ROGERS CENTRAL KITCHEN HVAC PROJECT

ADDENDUM #1

Date Issued: April 4th, 2025

ROGERS MS CENTRAL KITCHEN (B#24-025) ADDENDUM 1 SPECIFICATION NARRATIVE

ELECTRICAL POWER FLOOR PLAN E-103

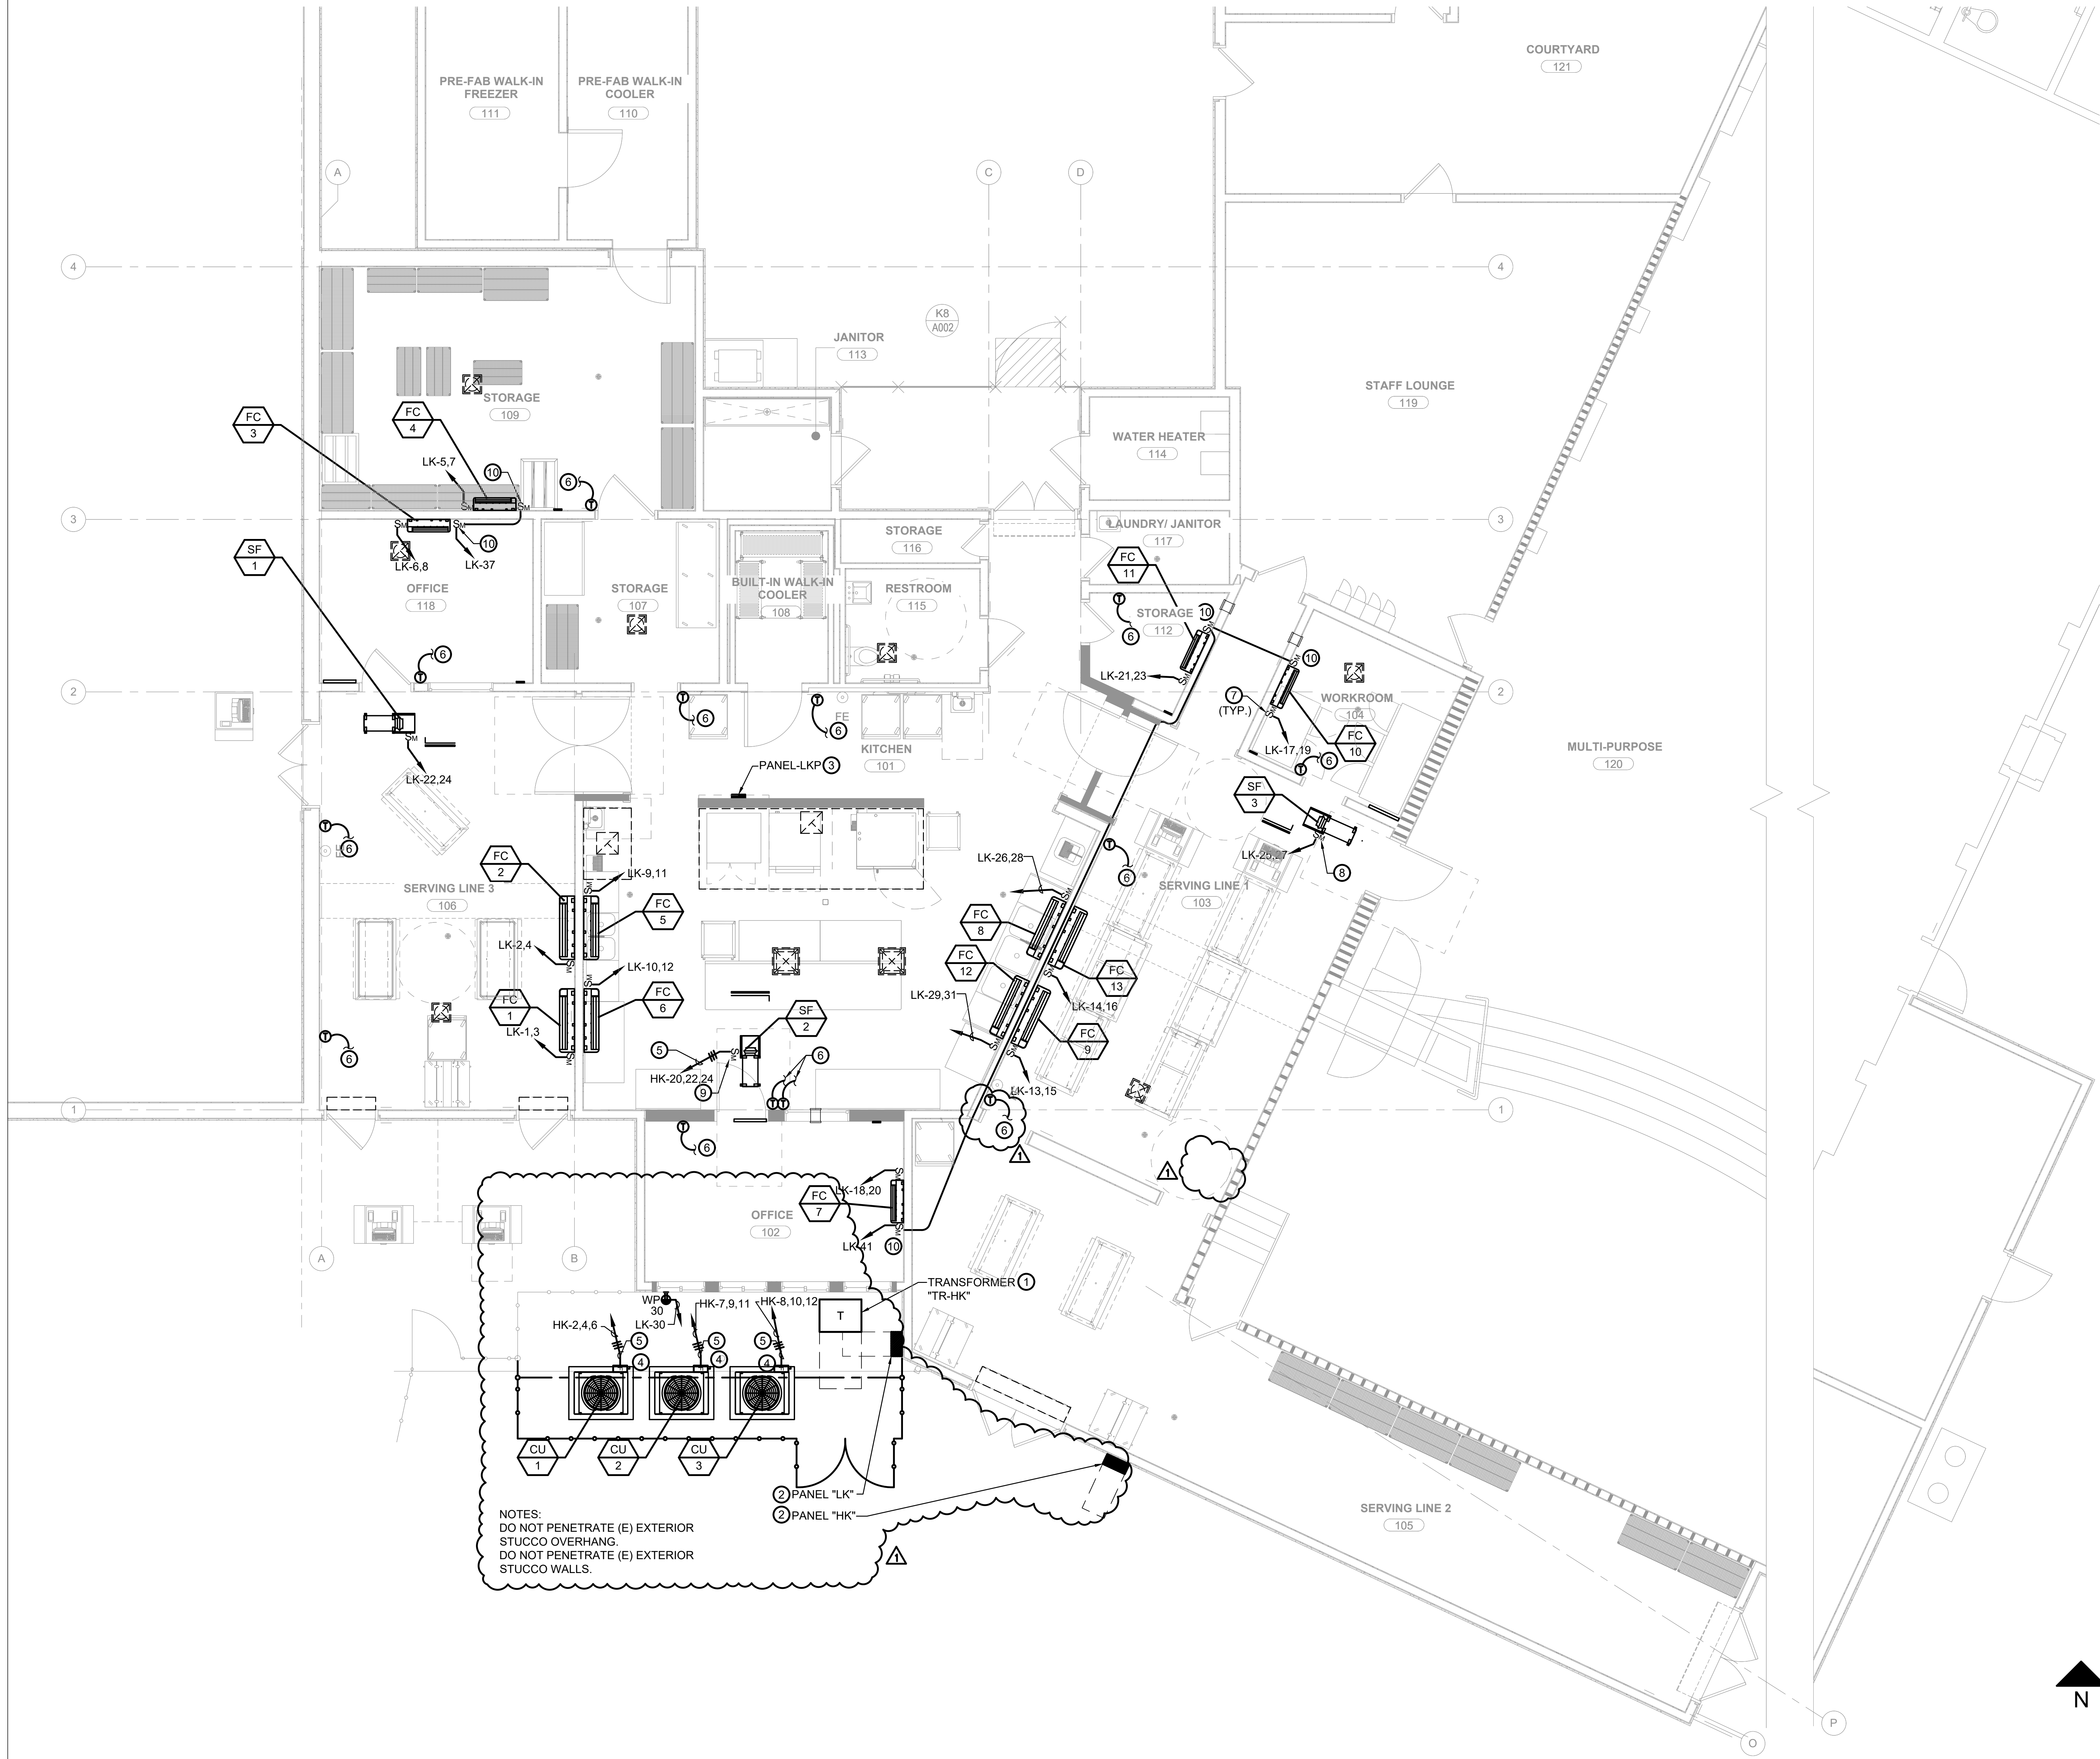
2. E-103 ELECTRICAL POWER FLOOR PLAN

- a) Revised location of Panel 'HK'.
- b) Added note to not penetrate existing exterior stucco overhang or existing exterior stucco walls.
- c) Relocated Transformer "TR-HK".
- d) Relocated weather-proof exterior power outlet.
- e) Revised location of Panel 'LK'.
- f) Relocated disconnects for CU's to be directly mounted to the CU's.
- g) Removed extra tstat in Serving Line 103.
